DESCRIPTIVE REPORT

Registry No. H-10988

General Locality Tongass Narrows

Sublocality Gravina Point to Ketchikan

Figure 1

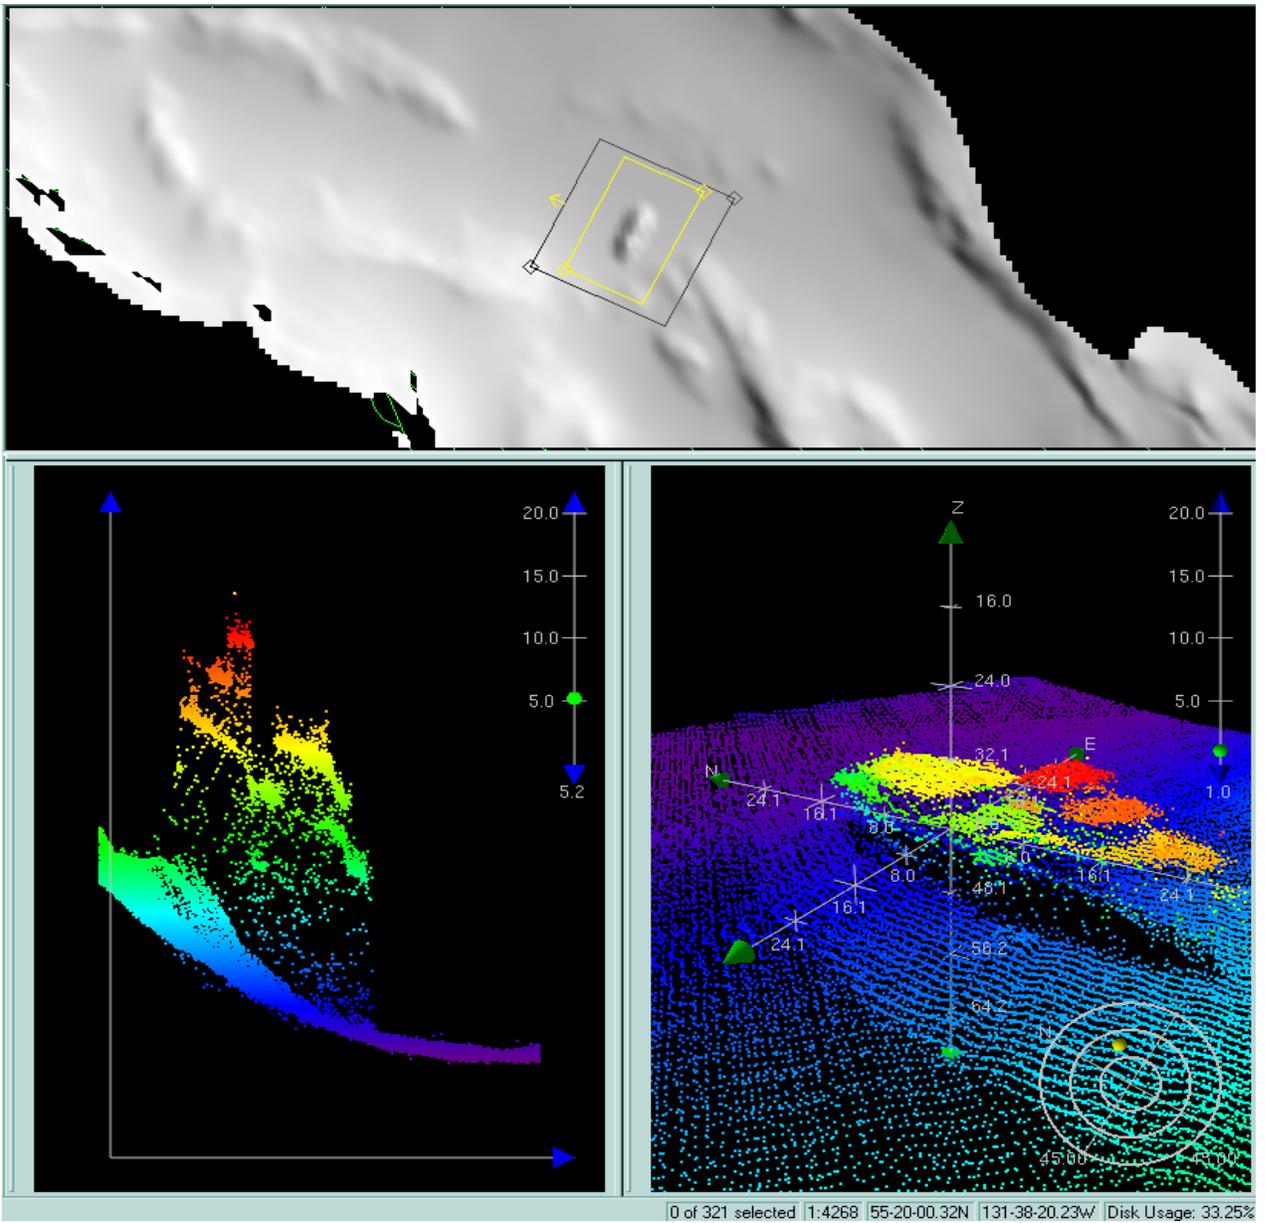
One new feature in the survey area was investigated.²⁶ Associated detached positioning data are mapped and detailed within the Shoreline Verification MapInfo database in Workspace file Ketch_ITBI.wor.²⁷ A summary of the new feature investigated is given in Table D.2.2.²⁸

²⁶ During office review a submerged wreck was discovered on the DTM and in the multibeam sounding records, see figures 1 and 2. Upon further investigation, this wreck is approximately 50 meters in length and 10 meters in width and has a depth of 14.2 fathoms. It is recommended that this *14 wreck* be charted at latitude 55/19/55.51N, longitude 131/37/53.14W. It is also recommended that this wreck be added to the AWOIS database and have additional work done to get a least depth and description of the wreck on a time available basis.
